NRC DOCKET 50-321
OPERATING LICENSE DPR-57
EDWIN I. HATCH NUCLEAR PLANT UNIT 1
PROPOSED CHANGES TO TECHNICAL SPECIFICATIONS

Subject: MAPLHGR Curves for Hatch 1

The proposed change to Technical Specifications (Appendix A to Operating License DPR-57) would be incorporated as follows:

FIGURE 3.11-1 (SHEET 4)

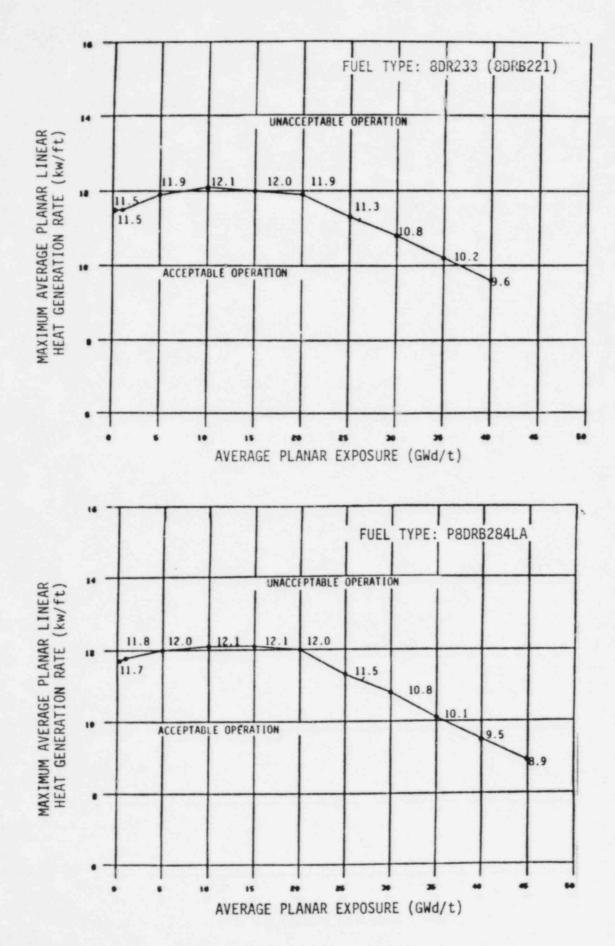
During power operation, the APLHGR for each type of fuel as a function of average planar exposure shall not exceed the limiting value shown in Figure 3.11-1, sheets 1 thru 5. If at any time during operation it is determined by normal surveillance that the limiting value for APLHGR is being exceeded, action shall be initiated within 15 minutes to restore operation to within the prescribed limits. If the APLHGR is not returned to within the prescribed limits within two (2) hours, then reduce reactor power to less than 25% of rated thermal power within the next four (4) hours. If the limiting condition for operation is restored prior to expiration of the specified time interval, then further progression to less than 25% of rated thermal power is not required.

Remove Page	Insert Page
3.11-1	3.11-1
3.11-3	3.11-3
Figure 3.11-1 (Sheet 1)	Figure 3.11-1 (Sheet 1)
Figure 3.11-1 (Sheet 2)	Figure 3.11-1 (Sheet 2)
Figure 3.11-1 (Sheet 3)	Figure 3.11-1 (Sheet 3)
	Figure 3.11-1 (Sheet 4)
	Figure 3.11-1 (Sheet 5)
Figure 3.11-4	Figure 3.11-4
Figure 3.11-5	Figure 3.11-5
